Adelaide Aquatic Centre - Public Consultation

Bike Adelaide is the leading voice engaging with local governments on cycling for transport issues across Greater Adelaide on an ongoing basis. I would like to present these comments in feedback to the consultation on the relocation of the Adelaide Aquatic Centre thus far.

Figure 2: Pardipardinyilla (Park 2) and surrounding area with cycling routes and conflict points

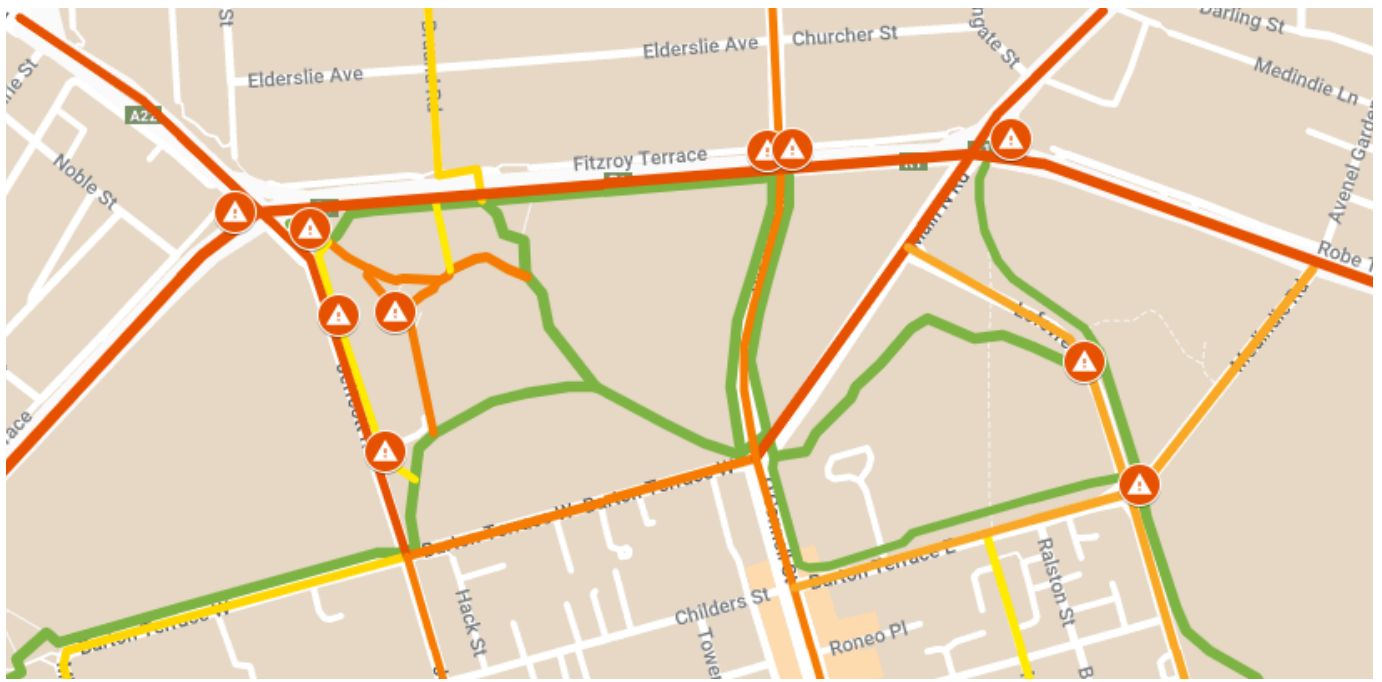
This colour-coded map demonstrates there are some good cycling connections to the Aquatic Centre and Pardipardinyilla but these are hampered by poor connections *into* the park from Prospect, Fitzroy Gardens, Medindie and Ovingham. With the exception of Braund Ave which is a City of Prospect designated bicycle route, there are no safe approaches to the Aquatic Centre by bicycle from the North. This is due to the separated paths terminating at Park, Fitzroy and Robe Tce and being separated from the north by very wide roads and intersections with high vehicle volumes and speeds. Access is further made difficult by long wait times and poor crossing connections at several intersections (eg Park Tce/Torrens Rd, O'Connell St/Main North Rd). This low amenity amplifies the danger of accessing the area by bike or by foot.

The map indicates several on-road routes in red which very few cyclists use due to the motor vehicle speeds and volumes and the lack of on-road bike facilities or safe ways to traverse intersections. Several more routes in orange intersect these red routes, highlighting poor connectivity, relying on streets with high risk of conflict with motorists on narrow 50kph roads, motorists entering and pulling out of car parking spaces and with motorists suddenly opening car doors.

Figure 2 further highlights the locations of several well known conflict points along the Park/Fitzroy/Robe Tce corridor. Most of these conflict points are at left-hand slip lanes, through which motorists seldom slow down or give way to those crossing. This poses a significant disincentive to people who may walk or cycle to the Aquatic Centre through frequent, negligent motorist behavior inherent to slip lanes.

Of note are several conflict points where pedestrians and cyclists must interact with motorists. Two such spots are the current Aquatic Centre carpark entrance and exit on Jeffcott St. Motorists entering often do so with little warning and with little regard for path users about to or already in the process of crossing. Motorists exiting the carpark often queue over the path, blocking path users from safely crossing. As a result of there being two exit lanes, motorists will seldom look for path users before pulling out or moving forward in the queue (as path users navigate the blocked crossing).

The overall lack of safe approaches emphasises the importance of retaining and realigning the existing paths within Pardipardinyilla to encourage cycling to the Aquatic Centre. This would have the benefit of helping alleviate demand on car parking space, reduce use of and the need for on-street parking and improve the options for families and young people to access the Centre without a car at all.

Option 1

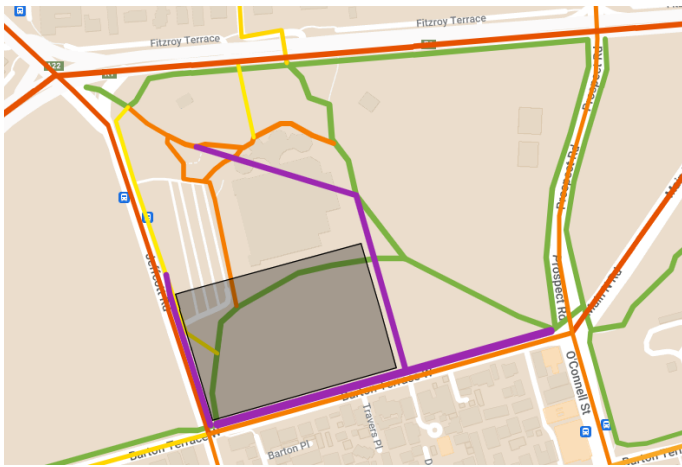
Each relocation option provides several opportunities for new shared-use paths and connections between new and existing paths, demonstrated in the following maps. Each of the three following maps shows the existing paths, the proposed Aquatic Centre sites (in black) and potential new path connections (in purple). In addition to these potential new paths, we strongly recommend that where paths cross a driveway into the Aquatic

Centre, it is made as a raised wombat crossing, affording priority to path users. This can positively affect access and safety for patrons but also ensure the path is able to flow freely when motorists are queuing to exit.
